Access Compliance Report Public Rights-of-Way (Curb Ramps)

Main Street: STARLIGHT_RIDGE Cross Street: SHASTA_CT Location: SE

ADA ID: RPRK211018174509 Ramp Type: Type 1 - Perpendicular Diagonal Initial Pass/Fail: Fail Overall Compliance: No Severity Score: 30

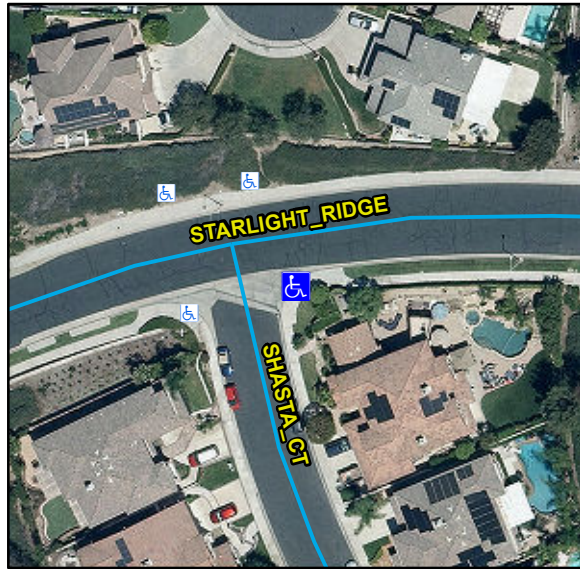
R304.2.2, R304.5.3, R302.7.2, STD 1115

Compliance	Description	Data	Compliance	Description	Data
N/A	Ramp Length (in)	82	N/A	Flare Type LT	
Yes	Ramp Width (in)	48			N/A
Yes	Ramp Run Slope (%)	4	N/A	Flare Slope LT (%)	N/A
No	Ramp Cross Slope (%)	11.3	N/A	Flare Traversable LT	N/A
N/A	Landing Present	N/A	N/A	Flare Type RT	
N/A	Landing Length (in)	N/A			N/A
N/A	Landing Width (in)	N/A	N/A	Flare Slope RT (%)	N/A
N/A	Landing Run Slope (%)	N/A	N/A	Flare Traversable RT	N/A
N/A	Landing Cross Slope (%)	N/A	N/A	DWS Provided	N/A
N/A	Landing Movement Obstructed?	N/A	N/A	DWS Contrast	N/A
	Landing Movement Type	N/A	N/A	DWS Length (in)	N/A
N/A	Landing Shared	N/A	N/A	DWS Full Width	N/A
N/A	Clear Space	Yes	N/A	DWS Offset Left (in)	N/A
N/A	Clear Space To Crosswalk (in)	N/A	N/A	DWS Offset Right (in)	N/A
N/A	Marked Crosswalk 1	No	N/A	Marked Crosswalk 2	No
	Crossing 1 Direction	N		Crossing 2 Direction	W
	Marked Crosswalk 1 Width (in)	N/A		Marked Crosswalk 2 Width (in)	N/A

N/A	Ramp Inside Crosswalk 1	N/A	Yes	Ramp Inside Crosswalk 2	N/A
	Crossing 1 Slope (%)	7.9		Crossing 2 Slope (%)	4.9
	Crossing 1 Cross Slope (%)	10.4		Crossing 2 Cross Slope (%)	4.9
N/A	Gutter Ponding	N/A	No	Curb Slope	6.2
No	Gutter Lip Height (in)	0.5		Road Run Slope (%)	6.2
N/A	Gutter Run Slope (%)	N/A		Road Cross Slope (%)	8.2
N/A	Gutter Cross Slope (%)	N/A			
Yes	Overall Surface Condition: Acceptable		Yes	Perp Joint Present	Yes
	Cross Gutter Present?	Yes		Spandrel Present?	Yes
	Replace Cross Gutter?	No		Replace Spandrel?	No

Remove & Replace Curb Ramp With Two New Directional Ramps or Equivalent.
